**From:** Planning  
**Subject:** FW: Application 3/2020/0978 - Lower Standen Farm Pendleton  
**Attachments:** Lower Standen Hey Farm Location Map 2.pdf

**Application 3/2020/0978 (LBC)**  
**Lower Standen Farm Pendleton**

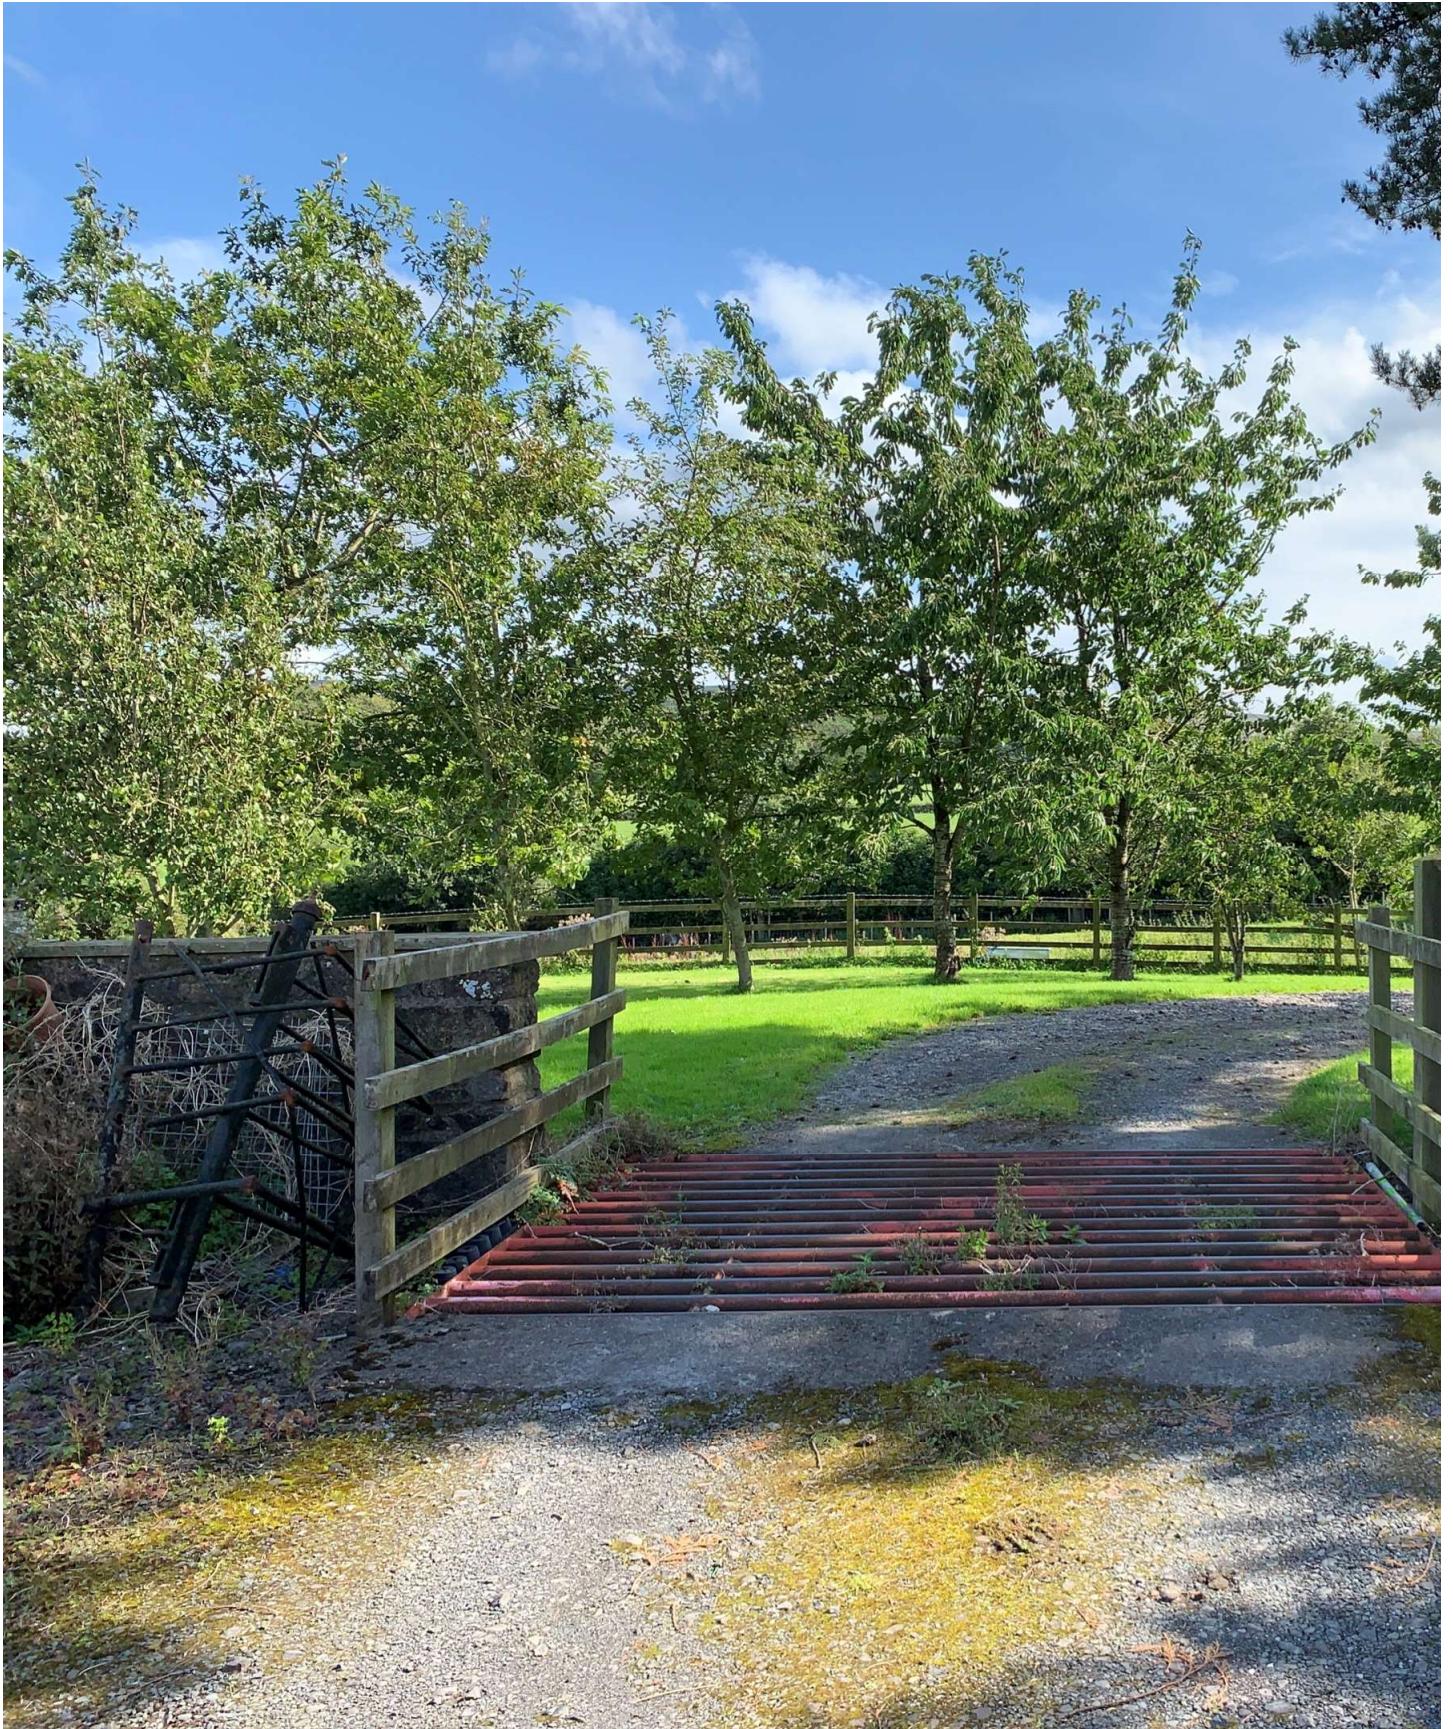
1) Clarification of how the proposed works demolish, alter or extend any part of the listed building:

Section 7 of the Act identifies listed building consent requirements – please show (including relevant drawings or other information) how the proposed works demolish, alter or extend any part of the listed building.

The proposed works would not demolish any part of the listed building. The only "demolition" would be the removal of:

- The 2x cattle grids.
- The short lengths of post and rail wooden fencing immediately associated with these cattle grids.
- The 5-bar wooden pedestrian hand gate next to the hard standing (shown in the photo attached to the RHS of the cattle grid in the photo).

The only element of alteration to any stonework would be the addition of a short length of wall to replace the pedestrian hand gate referred to above.

- The suggestion that this hand gate be removed is because it would serve no purpose once the associated cattle grid has been removed.

- I would note that the wall that we would be extended by approx 1m is itself only about 15 years old. This was built when the driveway and hard standing were constructed and post-date the listing.
